Title - Sujet Computer laboratory workbenches-ECC Computer laboratory workbenches-ECCC	
Solicitation No. - N° de l'invitation EF944-212498/A	Amendment No. - N° modif. 003
Client Reference No. - N° de référence du client R.112994.001	Date 2021-03-17
GETS Reference No. - N° de référence de SEAG PW-SMTA-625-16090	
File No. - N° de dossier MTA-0-43291 (625)	CCC No./N° CCC - FMS No./N° VME
Solicitation Closes - L'invitation prend fin at - à 02:00 PM Eastern Daylight Saving Time EDT on - le 2021-03-29 Heure Avancée de l'Est HAE	
F.O.B. - F.A.B. Plant-Usine: <input type="checkbox"/> Destination: <input checked="" type="checkbox"/> Other-Autre: <input type="checkbox"/>	
Address Enquiries to: - Adresser toutes questions à: Lavoie, Corine	Buyer Id - Id de l'acheteur mta625
Telephone No. - N° de téléphone (514) 207-4777 ()	FAX No. - N° de FAX () -
Destination - of Goods, Services, and Construction: Destination - des biens, services et construction: Voir doc.

AMENDMENT 003

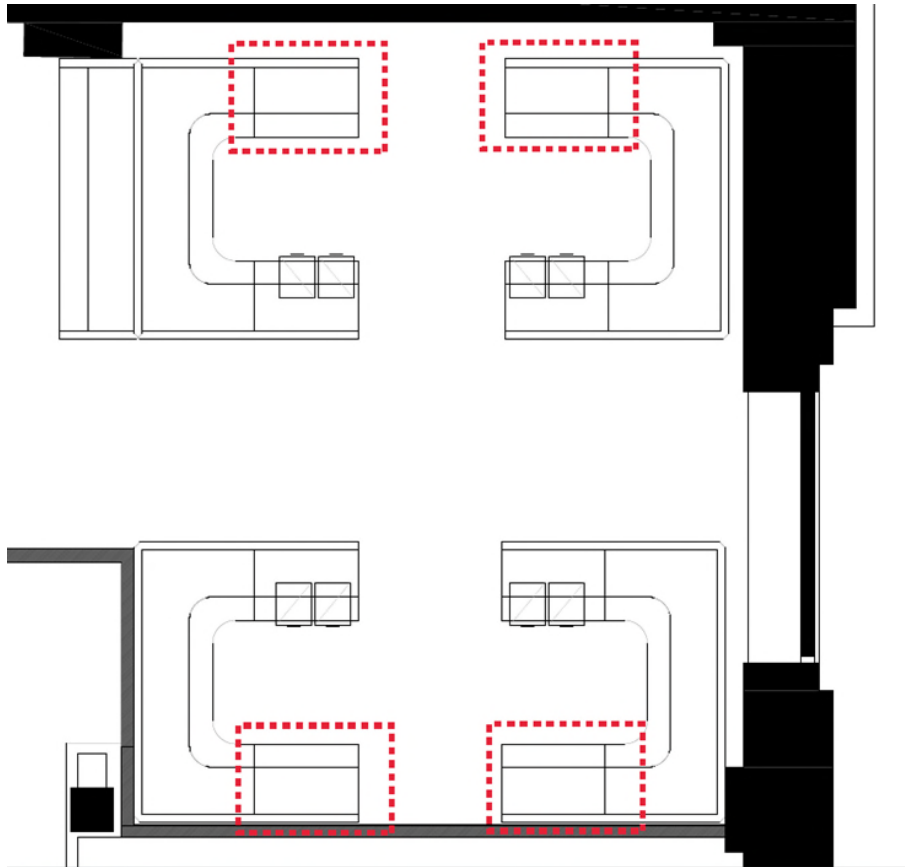
- Q3. With regards to part 3 – section 3.1.2.8 – Privacy Panels; the privacy panels must be open frame with the exception of two tackable upper elements to be removable. Can you advise what would be the general dimensions of these 2 tackable panels you're referring to?**

A3. This may be supplier dependent, but the width should fit within the vertical posts. The height can be approximately 12 inches (this may also be supplier dependent).
